Osprey 2  
 Modification to hull  
 addition of 4" forward of step  
 Dwg #2A

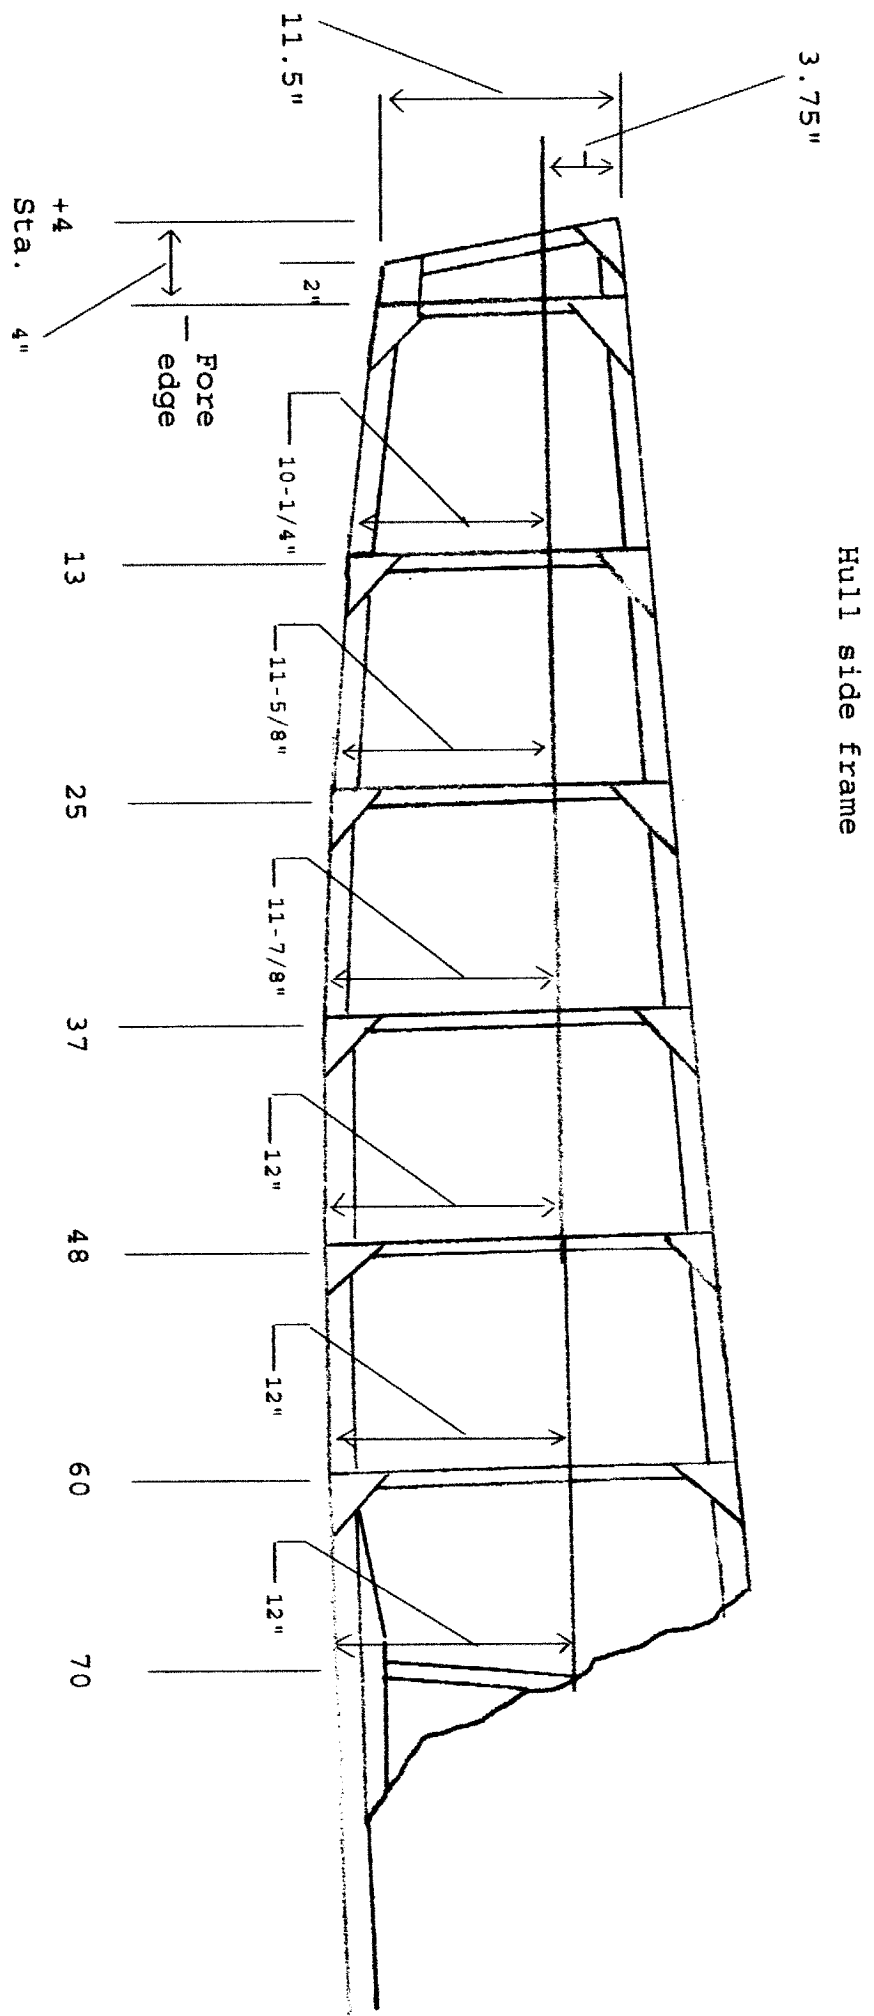
Note: Starting from side datum line, set the forward top longeron at 3-3/4" and strike a straight line to sta. 70 at 8-5/8". Bottom longeron has no change from original plans from sta. 25 aft to step.
